REGIONAL REVIEW NOTIFICATION

Name of Proposal: Fairburn Renaissance Mixed Use Development

Review Type: Development of Regional Impact

Preliminary Report:	March 15, 2006	DEVELOPMENT OF REGIONAL IMPACT REVIEW REPORT	Project:	Fairburn Renaissance #976
Final Report Due:	April 14, 2006		Comments Due By:	March 29, 2006

V/C Ratios

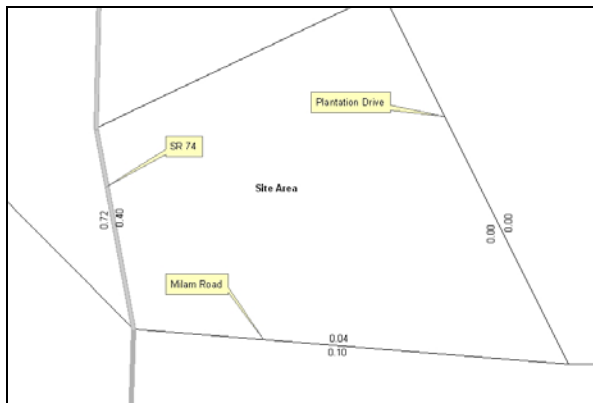
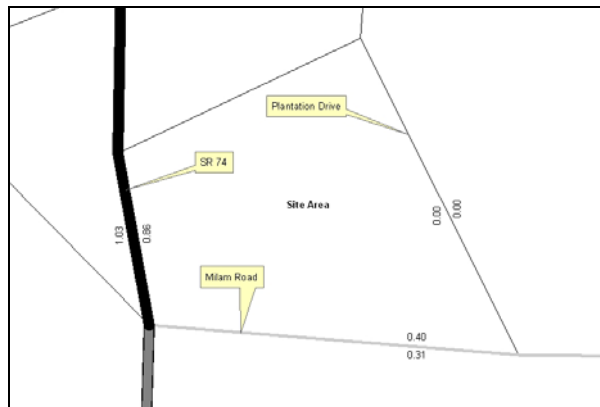
For the V/C ratio graphic, the data is based on 2005, 2010 and 2030 A.M./P.M. peak volume data generated from ARC's travel demand model for Mobility 2030, the 2030 RTP and the FY 2005-2010 TIP, approved in December 2004. The travel demand model incorporates lane addition improvements and updates to the network as appropriate. As the life of the RTP progresses, volume and/or V/C ratio
